AIP SUP
02/2025
Publication date 09 JAN 2025

AMSTERDAM/SCHIPHOL (EHAM): RECONSTRUCTION ENTRY/EXIT R-APRON

PHASE 25.0 (JAN-FEB 2025):

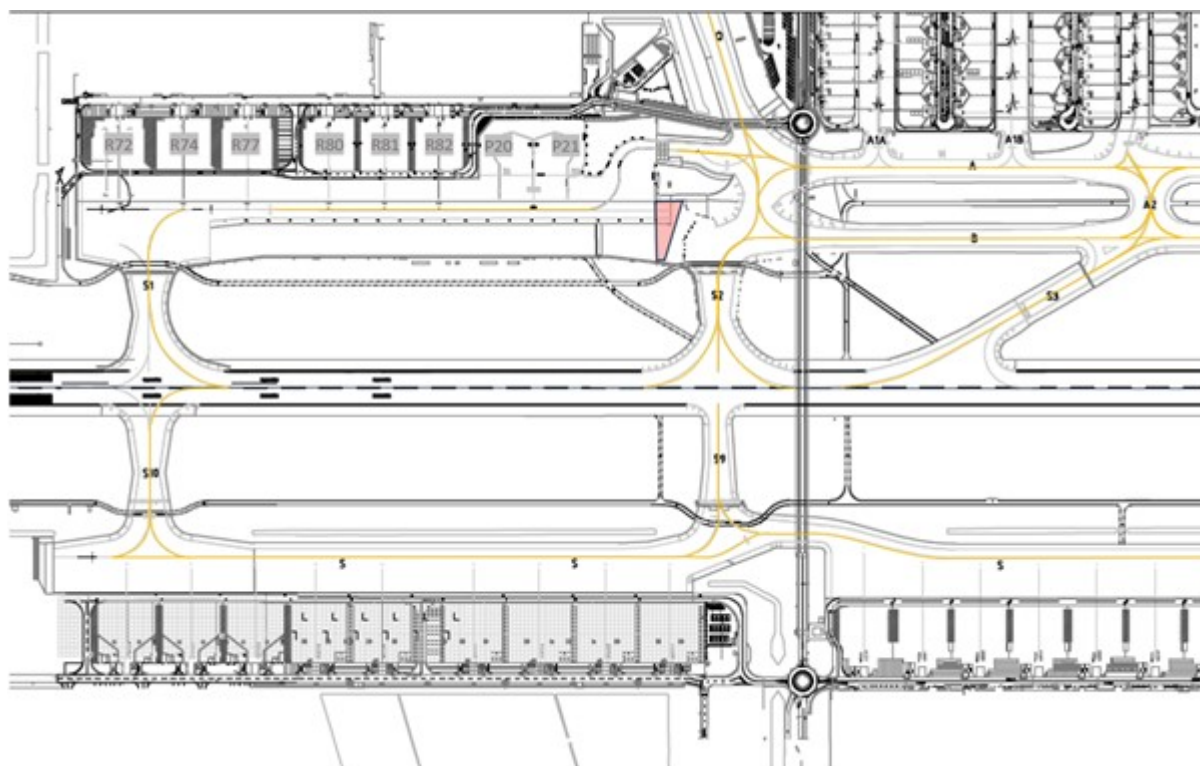
No work and no operational consequences. The availability is as follows:

- Remote holding positions P22 and P23: U/S.
- Entry/exit R-apron on TWY R moved to location P23.
- TWY S1 and S10: AVBL.

PHASE 25.1 (FEB-JUL 2025):

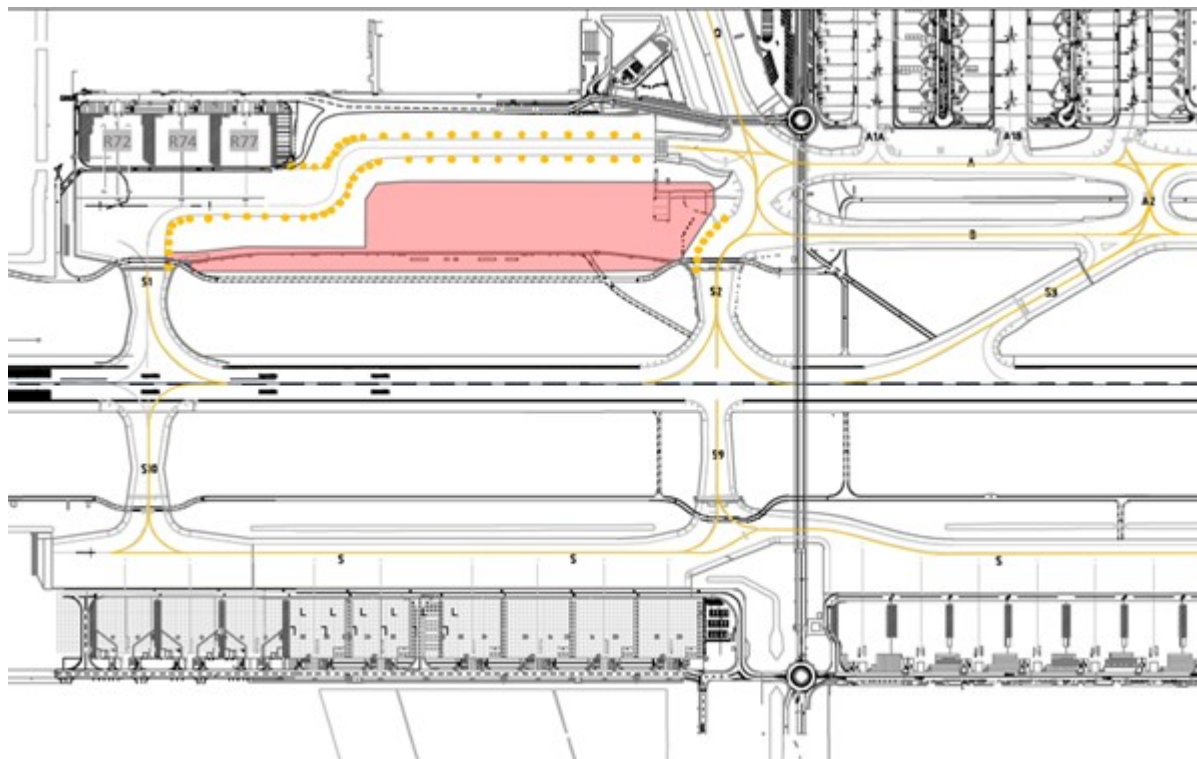
Work is carried out on former location TWY R. The availability is as follows:

- Remote holding positions P20-P21-P22-P23: U/S.
- Aircraft stands R80, R81, R82: U/S (withdrawn).
- TWY R replaced to former aircraft stands R80-R82 and remote holding positions P20-P23.
- Entry/exit R-apron on TWY R moved to location P23.
- TWY R MAX wingspan > 69 M guided by marshaller.
- TWY R no CL lights, if RVR 350 M or less marshaller guidance required.
- TWY S1 and S10: AVBL.

PHASE 25.2 (JUL-NOV 2025):

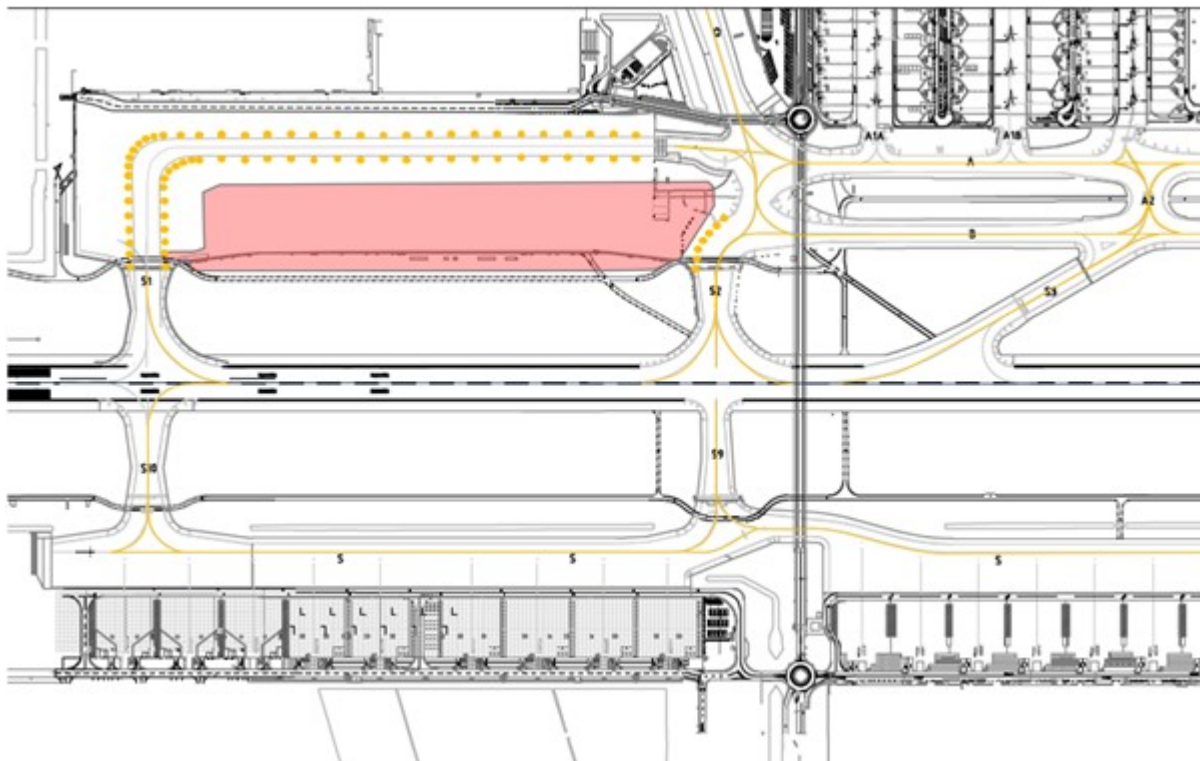
Work is carried out on former location TWY R. The availability is as follows:

- Remote holding positions P20-P21-P22-P23: U/S.
- Aircraft stands R71, R72, R73, R74, R77, R80, R81, R82: U/S (withdrawn).
- TWY R replaced to former aircraft stands R71-R82 and remote holding positions P20-P23.
- Entry/exit R-apron on TWY R moved to location P23.
- TWY R MAX wingspan > 69 M guided by marshaller.
- TWY R no CL lights, if RVR 350 M or less marshaller guidance required.
- TWY S1 and S10: AVBL.

PHASE 25.3 (NOV 2025 - JAN 2026):

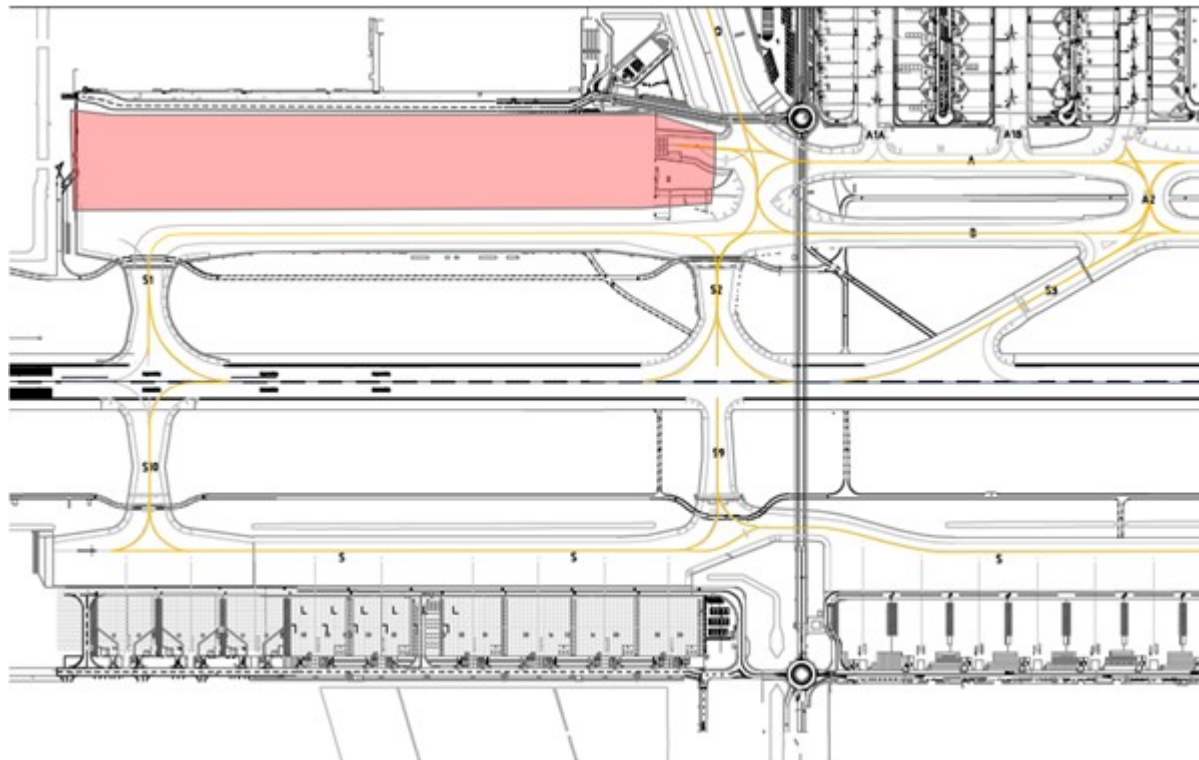
Work is carried out on former aircraft stands R71-R82 and remote holding positions P20-P23. The availability is as follows:

- Remote holding positions P20-P21-P22-P23: U/S.
- Aircraft stands R71, R72, R73, R74, R77, R80, R81, R82: U/S (withdrawn).
- TWY R restored to former location.
- TWY R MAX wingspan > 69 M guided by marshaller.
- TWY S1 and S10: AVBL.
